PROPOSED McDONALD'S BUILDING AT CALOUNDRA SOUTH:

CNR AURA BOULEVARD & GRAF DRIVE,
BARINGA QLD 4551.

DEVELOPMENT APPLICATION - SIGNAGE

Approval no: DEV2021/1209
Date: 21-Oct-2021

PYLON SIGN

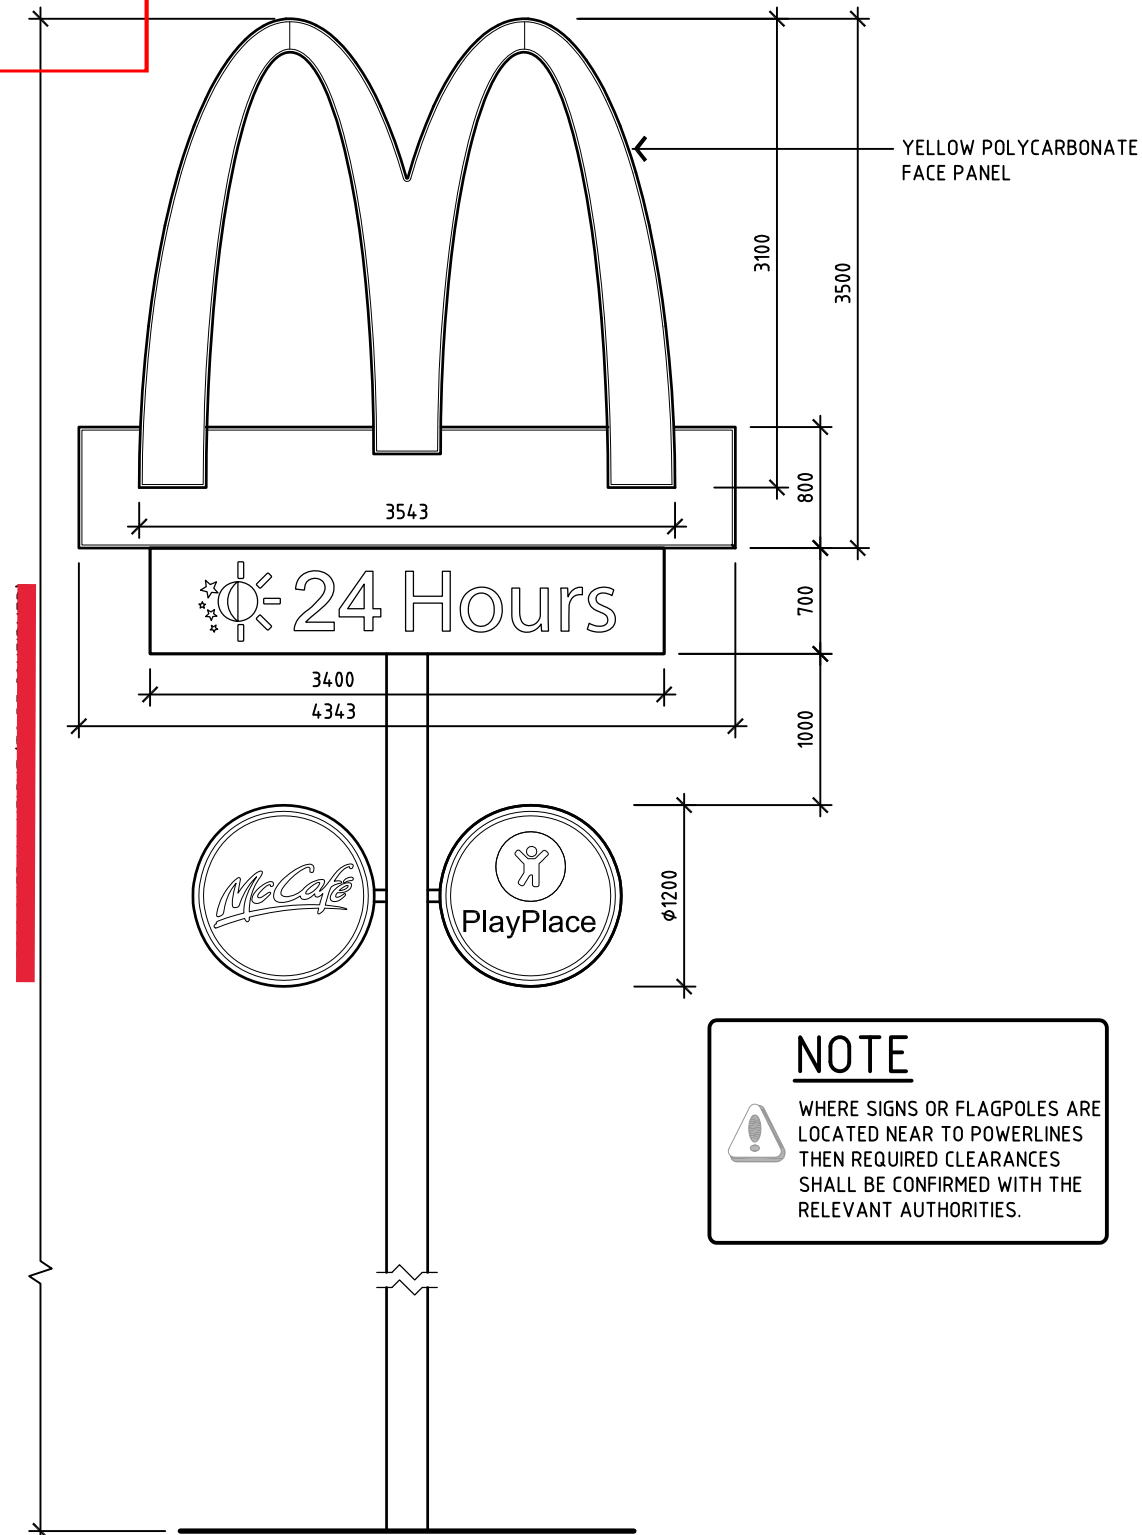
overall height
7.5m

AMENDED IN RED

01 OVERALL SITE - SIGNAGE LICENCE PLAN - STAGE 1

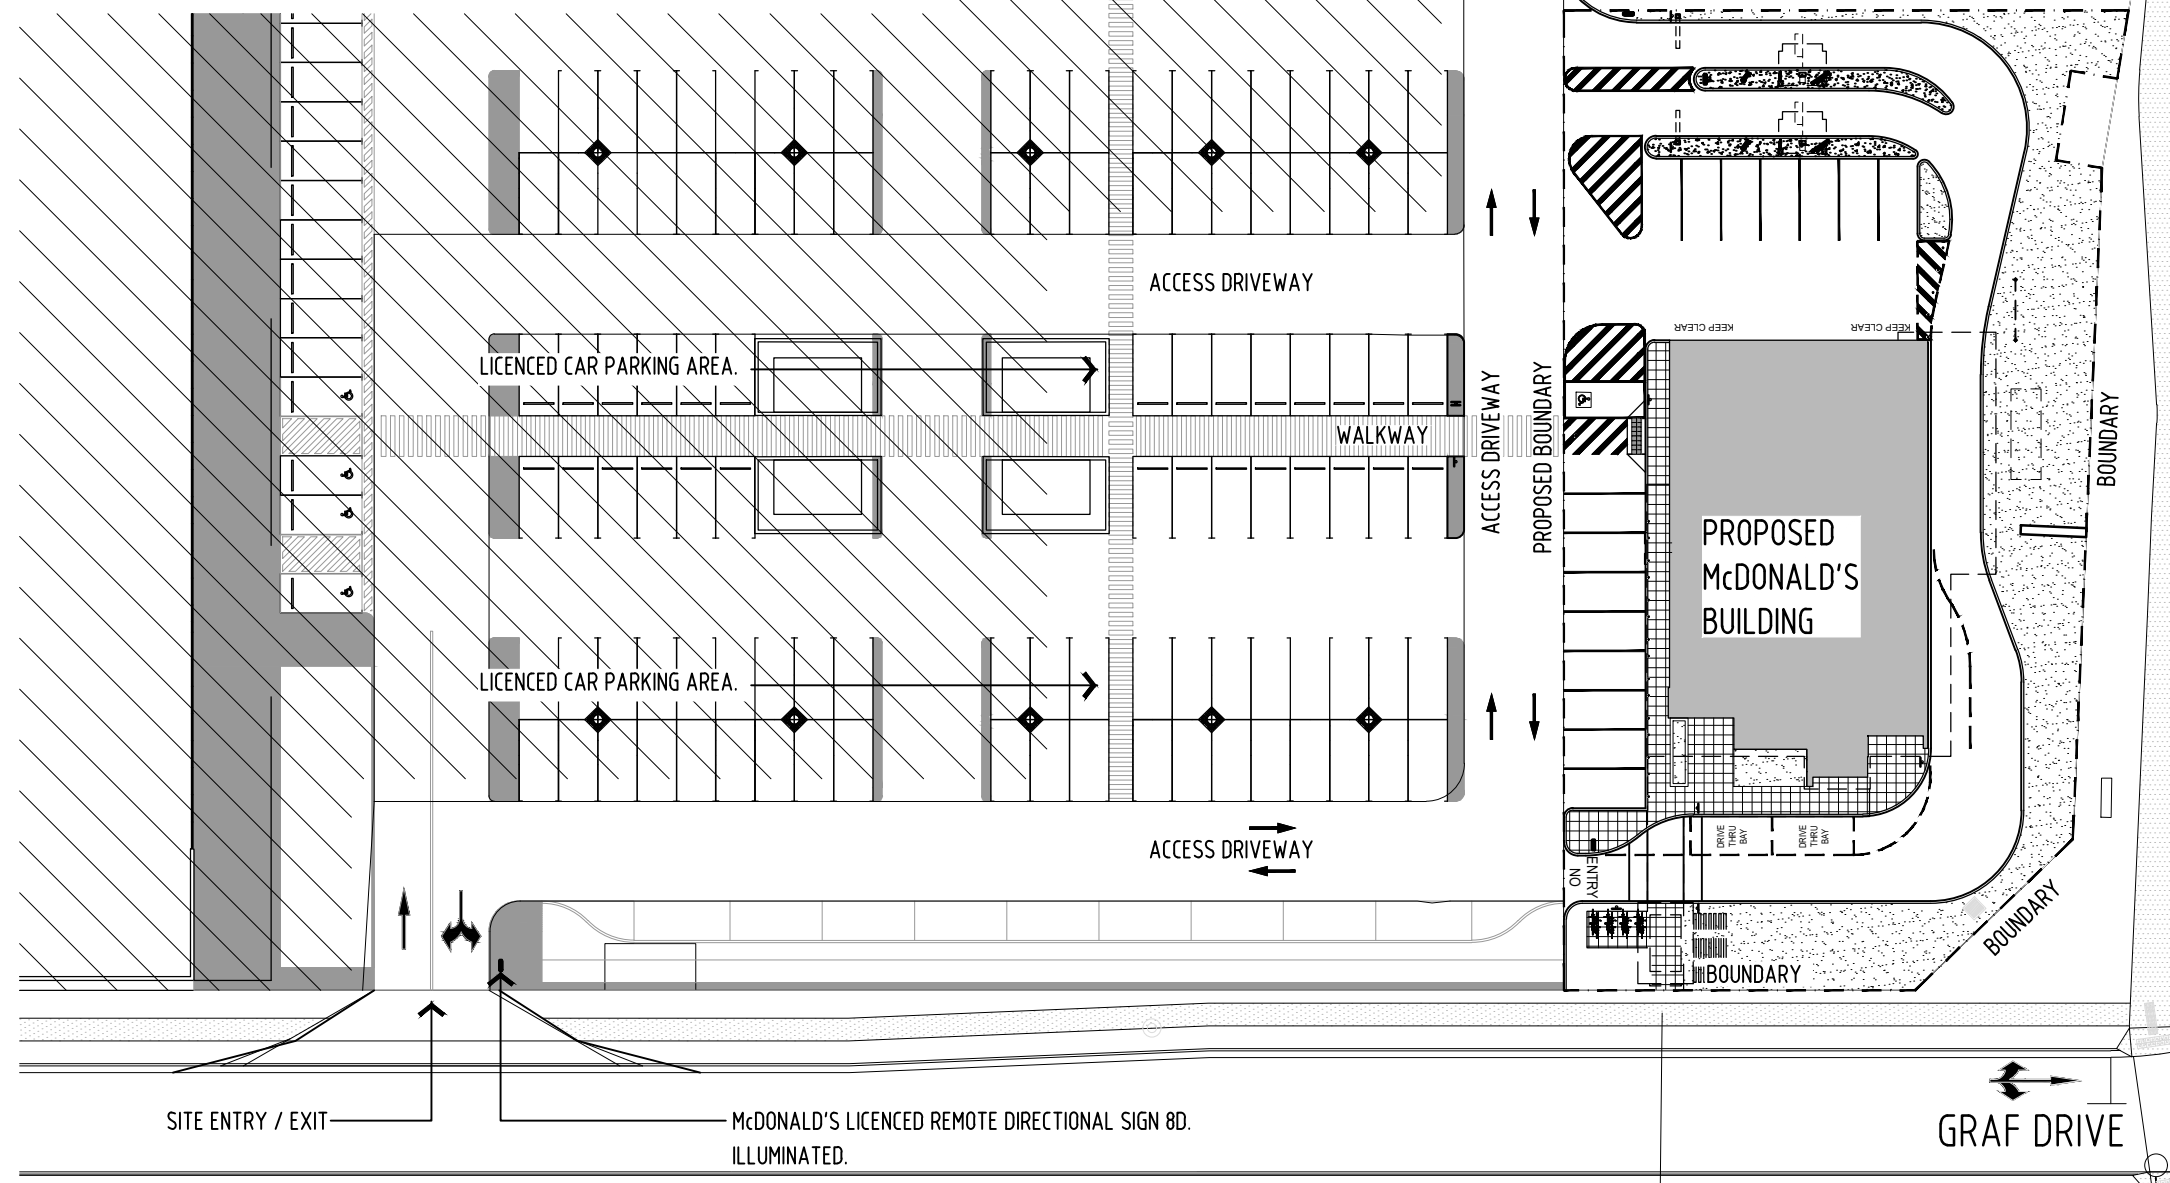
REV	AMENDMENT	DATE	INT.	NOTES
A	LICENCED REMOTE SIGN S8D RELOCATED	31.08.2021	MM	1. DO NOT SCALE THIS DRAWING. 2. THE DRAWING SHOWS DESIGN INTENT ONLY. ALL DIMENSIONS TO BE CHECKED ON SITE PRIOR TO CONSTRUCTION OR PRODUCTION. CONSTRUCTION DETAILS TO BE CONFIRMED BY CONTRACTOR /MANUFACTURER. 3. THIS IS A COMPUTER GENERATED DRAWING . DO NOT AMEND BY HAND.
				4. FIGURE DIMENSIONS ARE TO BE USED. CONTACT ARCHITECT FOR CLARIFICATION IF DIMENSIONS ARE NOT CLEAR. 5. ALL DISCREPANCIES AND OMISSIONS ON SITE MUST BE REPORTED TO THE ARCHITECT FOR THEIR COMMENTS OR APPROVAL PRIOR TO COMMENCING WORK. 6. ALL DIMENSIONS ARE IN MILLIMETERS
